From: [Jared Romero](#)
To: [Derek Bohannon](#)
Cc: [Ron Bohannon](#); [Chen, Tiequan](#); [Martinez, Richard](#); [Hughes, James D.](#); [Nicole M. Friedt](#); [Montoya, Anthony](#)
Subject: Re: [#2023004] 10088 Coors NW - 7 Bar Retail - AMAFCA Comments
Date: Monday, March 24, 2025 10:02:25 AM
Attachments: [image001.png](#)
[image.png](#)
[image.png](#)
[image.png](#)
[image.png](#)
[AMAFCA General Construction Notes and Requirements 11-2024 FOR OTHER PROJECTS.doc](#)

Below are AMAFCA's comments on the plans dated March 2025 for the 7-Bar Retail Project. Please provide a comment disposition sheet with the resubmittal detailing how each comment below is addressed or acknowledged.

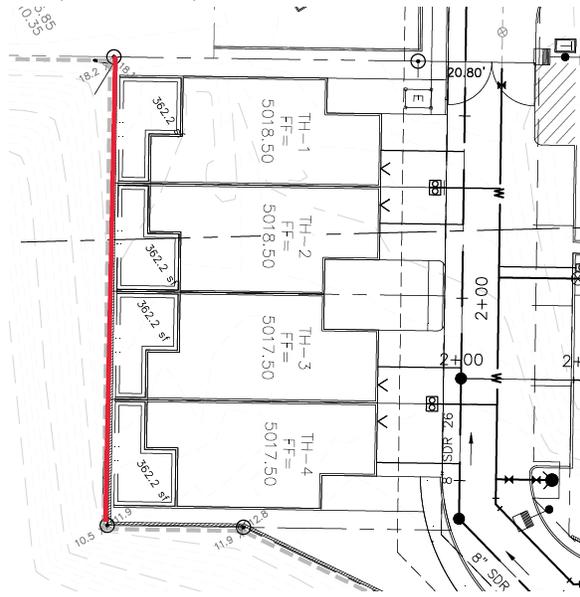
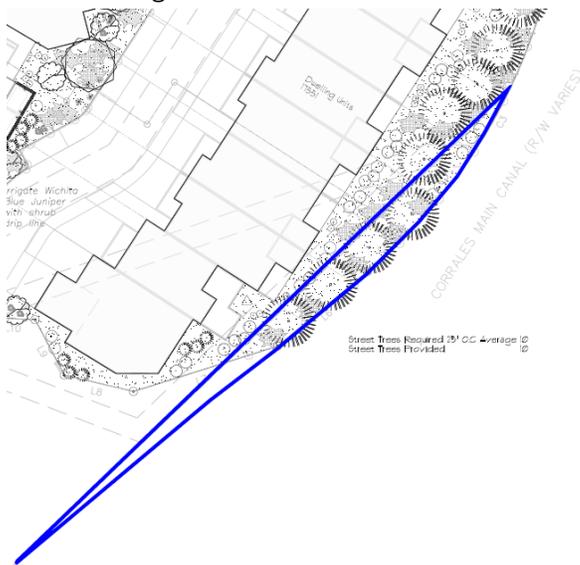
- Identify the finish grades on both sides of the wall; the plans only show the low side FG of the walls.
 - There was no wall profile provided for the proposed retaining wall on the southwest side of the project adjacent to the AMAFCA pond. Its unclear if this will

be a new wall or if the existing wall is to remain. If it is to remain, note that on the plans as protect in place.
